**ELEVENTH EXHIBIT (NONCONFIDENTIAL) TO THE
PREFILED DIRECT TESTIMONY OF**

Assessment of Proposed Energize Eastside Project

Technical review with respect to Section 18.44.052
of the City of Newcastle Municipal Code

Prepared for the City of Newcastle
June 2020 Update¹

Figure 3. Modified heat map

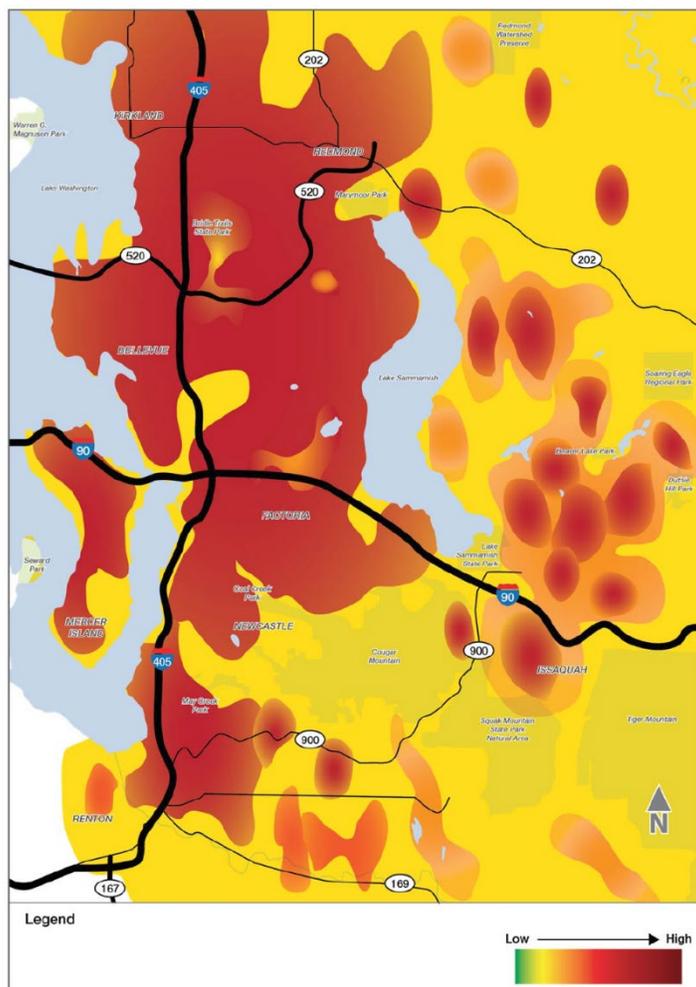
The 2013 Eastside Needs Assessment Report includes a heat map that PSE claimed is a depiction of electric load density. However, we note that this map shows the most densely populated areas in and around the Eastside (see Figure 3) which do not necessarily coincide with electric demand. We conducted power flow models in the Northwest area serving the South King county zone using historical and projected peak demand for King County.¹⁸ We ran the models employing the base cases provided by the Western Electricity Coordinating Council (WECC) and varying key sensitivities while maintaining the projected peak demand constant to evaluate regional grid conditions under various contingency events.

Figure 5. PSE entire service territory: winter peak load forecasts and actual peak load

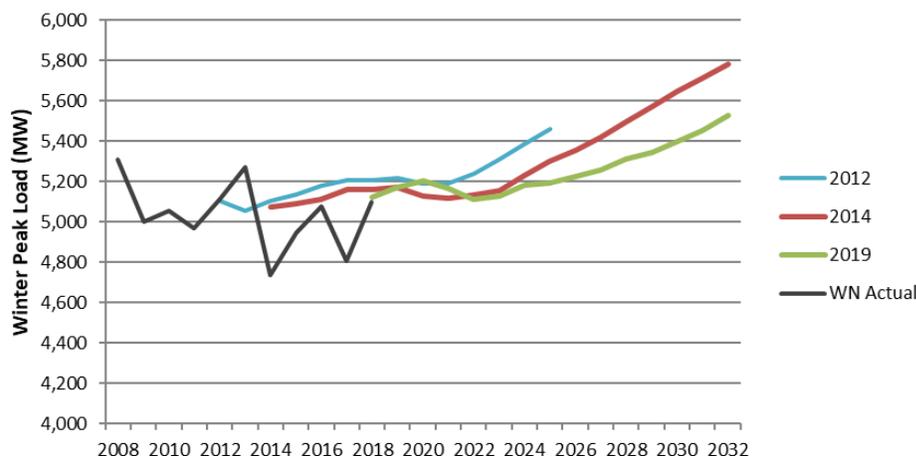
Figure 5 presents PSE's load forecasts for its service territory made in 2012, 2014, and 2019 along with weather-normalized actual winter peak loads (*i.e.*, loads adjusted for the specific weather impacts seen each year). These loads represent loads including the demand-side resource potential estimated in PSE's IRPs except peak load impacts from any demand response or distributed generation. These load data are also adjusted for PSE's transmission-level customers that are not included in PSE's corporate load forecasts.³³ This figure shows that the historical winter peak loads have been lower than what PSE's load forecasts have projected in the past, except in 2012.³⁴ It is also important to note that there has been a slight declining trend in the historical weather-normalized peak loads over the past 10 years. The annual average growth rate over the past 10 years is -0.4 percent. PSE did not project this decline. In fact, PSE's forecasts show increasing loads into the future years, and past forecasts showed increasing load during the time period when actual loads have declined. In addition, newer forecasts show lower peak loads than previous forecasts, and the time at which peak loads are projected to rise substantially appears to be shifting into the future with each forecast.

Figure 6. PSE King County: winter peak load forecasts and actual peak load

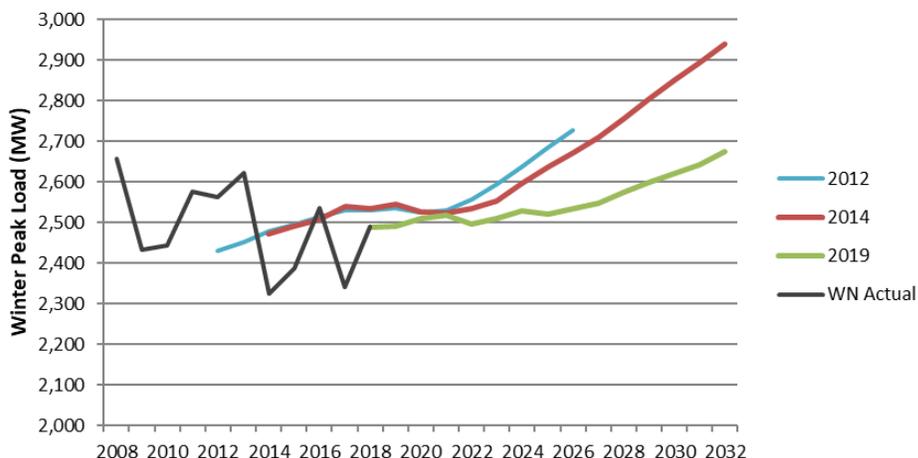
Historical loads and PSE’s peak load forecasts for King County also show similar trends to what we have observed in PSE’s entire jurisdiction, as shown in Figure 6. Both the historical loads and projected loads in this figure include additional peak loads expected from transmission-level customers.³⁶ Historical

weather-normalized peak loads have been lower than forecasted weather-normalized peaks in four of the five most recent years (from 2014 to 2018 except 2016).³⁷

Figure 7. PSE King County: winter peak load estimates vs. peak load thresholds

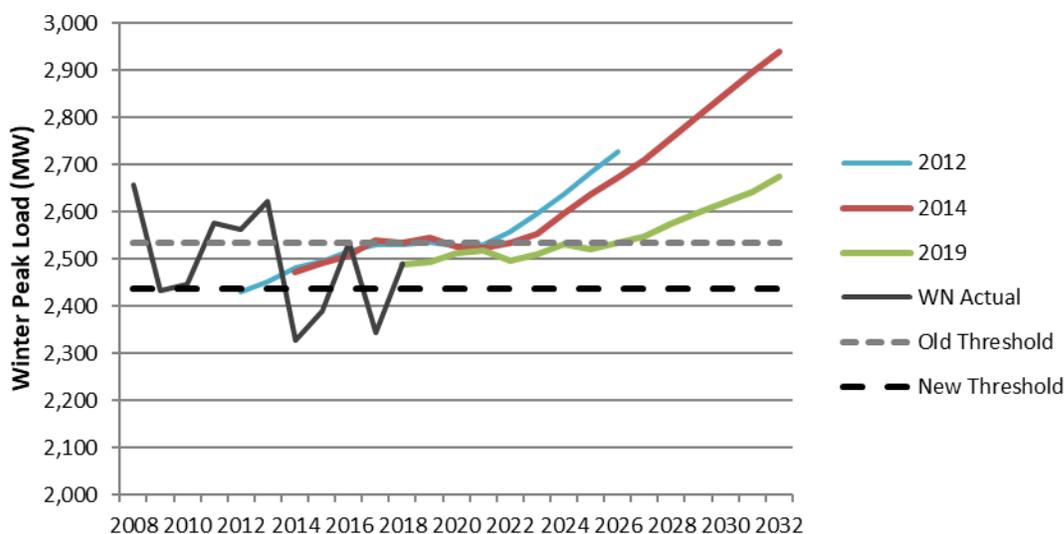
Figure 7 includes two separate estimates for load thresholds, labeled as “Old Threshold” and “New Threshold.” The “Old Threshold” represents a load threshold (or a level of concern) that was estimated in the 2013 and 2015 Eastside Needs Assessment report, scaled from the full PSE service territory to King County. During our investigation of the needs for the Eastside, we learned that PSE switched to EPRI’s PTLOAD software to characterize its transformers. This change resulted in a reduction in the MW threshold, primarily due to different assumptions regarding the performance of grid components that are built into the PTLOAD model. The “New Threshold” in Figure 7 reflects this new estimate. For the PSE service territory, the thresholds were reduced from 5,200 MW to 5,000 MW for the winter period

A comparison of the loads in Figure 7 reveals that the recent actual winter peak loads have been lower than the Old Threshold, but were above the New Threshold in 2016 and 2018.³⁹ PSE’s latest load forecast developed in 2019 shows projected load levels above the new load threshold starting in 2018, although only by about 50 to 80 MW (or 2 to 3 percent) over the next few years. The average annual growth rate over the past decade is -0.65 percent. As with the case of the system-wide peak load forecasts, PSE did not project this declining peak load in its past forecasts. PSE’s latest forecast still shows an increasing winter peak trend. While the 2018 peak load is above the New Threshold, we are not convinced that the loads will remain above the New Threshold because PSE’s winter peak load forecasts have historically over-projected winter peak loads. The current forecast may have a bias in projecting higher peak loads and not fully reflecting historical winter peak trends, just like the gap the WUTC identified between the annual electric sales forecasts and actual sales from 2006 to 2014 as mentioned above. Further, there is a possibility that future loads may not increase as much as PSE is projecting or even could be lower than the New Threshold if PSE follows the WUTC’s recommendation

Figure 8. PSE service territory: summer peak load forecasts and actual peak

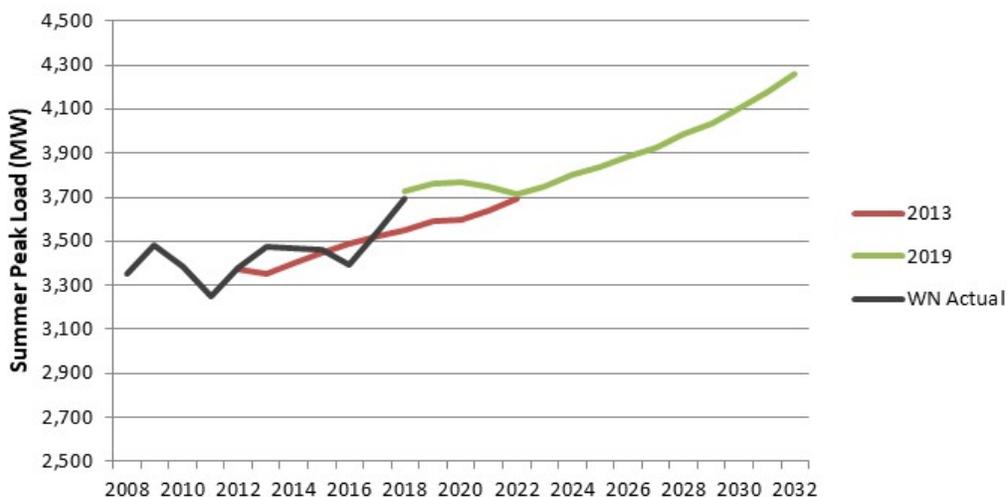
PSE’s summer peak loads present a very different story than the winter peak loads. Figure 8 presents PSE’s load forecasts for its entire service territory made in 2013 and 2019, along with weather-normalized actual, historical summer peak loads through 2018 (*i.e.*, loads adjusted for annual specific weather impacts). As with the winter peak load estimates, the summer peak load estimates include loads for PSE’s transmission level customers.⁴¹ The load forecasts also represent loads adjusted for 100 percent of the demand-side resource potential estimated in PSE’s IRPs. This figure shows that, unlike the historical winter peak loads, the historical summer peak loads have been increasing over the past several years, as forecast by PSE in 2013. Further, unlike PSE’s winter peak forecast, the load for the first year for each forecast matches closely with the weather-normalized actual, historical loads (*i.e.*, year 2012 and 2018).

Figure 9. PSE King County: summer peak load forecasts and actual peak load

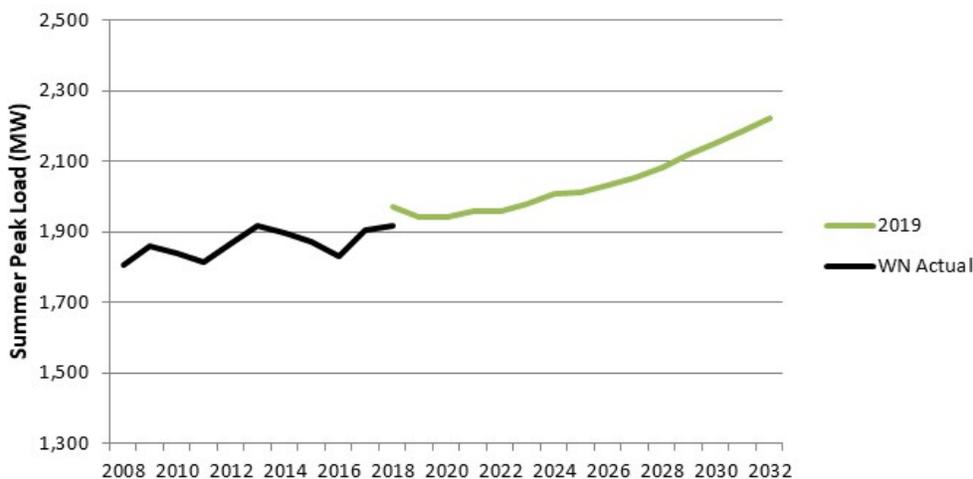
Historical and forecasted summer peak loads for King County show similar trends to the loads for PSE’s entire service area, as shown in Figure 9.⁴² Summer peak loads have been gradually increasing over the past several years, and PSE’s forecast shows a growing peak load trend into the future. This figure includes just one forecast (made in 2019) because PSE’s Eastside Needs Assessment studies did not analyze summer peak loads at the King County level, but instead focused on winter peak loads for the Eastside area as well as for the entire service territory.⁴³

Figure 10. PSE King County: summer peak load estimates vs. peak load thresholds

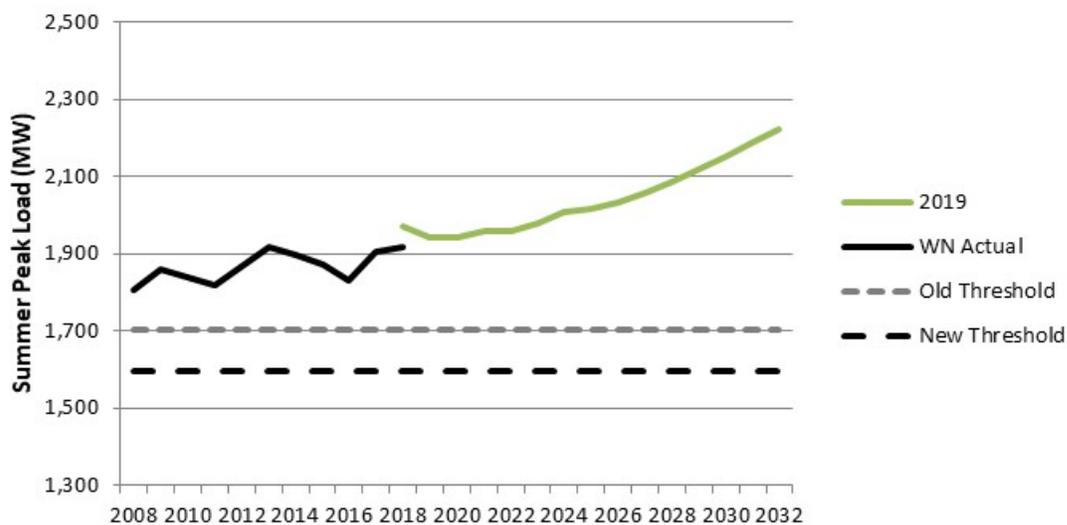
Finally, we examined the potential of summer capacity constraints in King County. Figure 10 presents this review by providing a comparison of the summer peak loads with peak load thresholds (the load levels of concern in King County at which key transmission facilities will be overloaded under contingencies (*i.e.*, N-1-1)). As mentioned above in the winter peak load discussion, PSE revised its previous load threshold calculation methodology. Its new estimate is shown as “New Threshold” (1,594 MW) in Figure 10. Because the 2013 and 2015 Needs Assessment reports did not provide any load threshold for King County, we estimated the “Old Threshold” for King County based on the ratio of load threshold changes at the PSE’s service territory level. At the total system level, the 2013 and 2015 Needs Assessment reports found system overloads could occur as early as 2014 and become more serious by Summer 2018.⁴⁴

A comparison of the load thresholds in Figure 10 reveals a more severe situation than found in the 2013 and 2015 Needs Assessment for the summer peak period: King County’s summer peak loads have been exceeding the level of load concerns under N-1-1 contingencies both at the old and new threshold levels. More specifically, the peak load levels in King County have been 13 to 20 percent (or 200 MW to 300 MW) above the new threshold (assuming PSE’s latest threshold is accurate). Given this current severe condition, we do not need to rely on load forecasts to determine the capacity needs because it would be infeasible to acquire sufficient demand-side resources to reduce this substantial gap within just a few years. At the current load levels, we have to conclude that there is an operational need to expand the transmission capacity in the region.
